To: Elm Creek WMO Commissioners

Subject: Three Rivers Park Reserve District Hassen Dog Park Stairs

Photograph of Proposed Stair Location Over Existing Foot Path in Crow-Hassan Dog Park

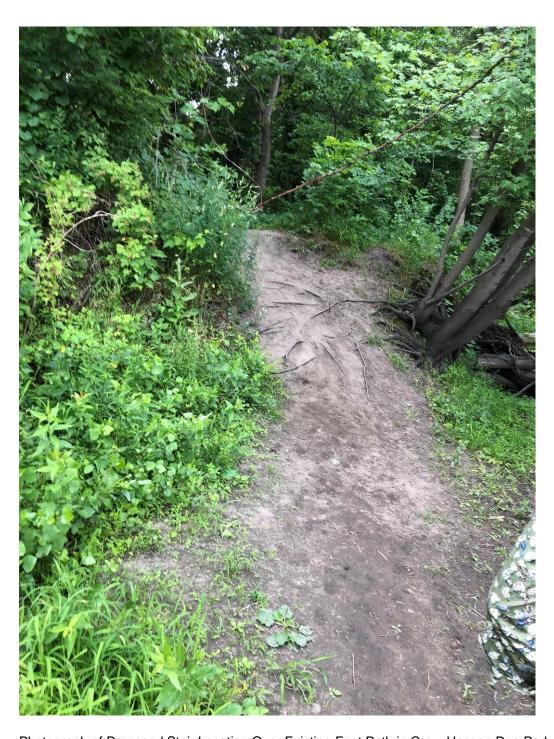
Three Rivers Park District is considering constructing a 15' long by 3' wide helical pile supported staircase to provide access to the Crow River in the Crow-Hassan off-leash dog park. The stairs will provide a safe access over an existing foot path that is steep and is covered in tree roots. A photograph of the foot path over the bank is shown below as well as the proposed Glulam stairs. The construction of these stairs will reduce erosion near the Crow River caused by foot traffic over the bank, which is limiting the growth of vegetation that reinforces the bank resulting in significant erosion. Elm Creek watershed staff visited the site of the proposed stairs on July 1, 2021.

Under Elm Creek WMC's rules, construction of the proposed stairs in the sand bar area would be classified as a "*land disturbing activity*" adjacent to the Crow River, and therefore would trigger watershed rules D, E, I and possibly F. Based on the limited site design, I recommend to the Commission that the rules be waived due to the limited impact as explained below.

The proposed alteration would require a negligible amount of site disturbance and includes no new impervious surfaces. Therefore, construction of BMP's to meet the Commission's rate controls, water quality controls, and volume controls is not applicable. Similarly, erosion and sediment controls for the plan are not necessary as construction/placement of these erosion control devices will create more disturbance than the project itself. The proposed helical piles will ensure that existing root wads remain in-place resulting in reduced erosion.

Staff have discussed the placement of riprap around the stairs to locally reduce the velocity and limit scour around the stairs. Because the existing foot path has resulted in erosion of the site, the placement of a small amount of riprap to restore the bank is not considered floodplain fill (as it is not reducing the conveyance of the Crow River).

Pursuant to Rule I.5.g.i, an unimproved access strip through the buffer less than 20 feet wide, is allowed for recreational access to the watercourse.
